PERCOLATION CERTIFICATION PLAN
12010 SIMPSON RD

5th ELECTION DISTRICT HOWARD COUNTY, MARYLAND
TAX MAP - 41 GRID - 1 PARCEL - 333

ON-SITE SEWAGE DISPOSAL SYSTEM DESIGN PLAN
12010 SIMPSON RD

SEPTIC PROFILE

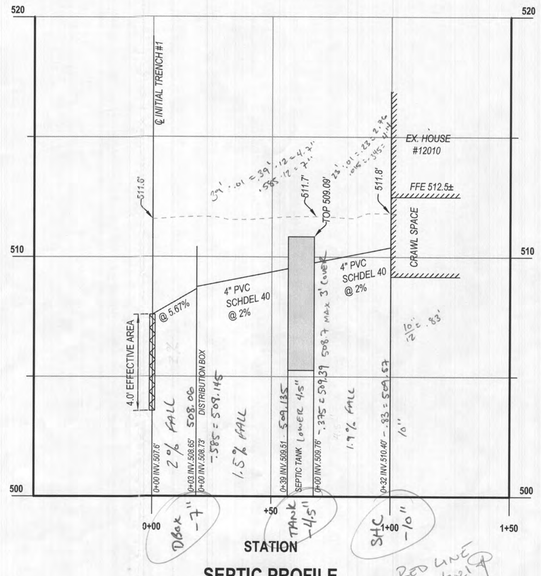
RED LINE 11/16/2021

* BED IN STONE OR Rock Dust - SHC & EFF. LINE TO Box.
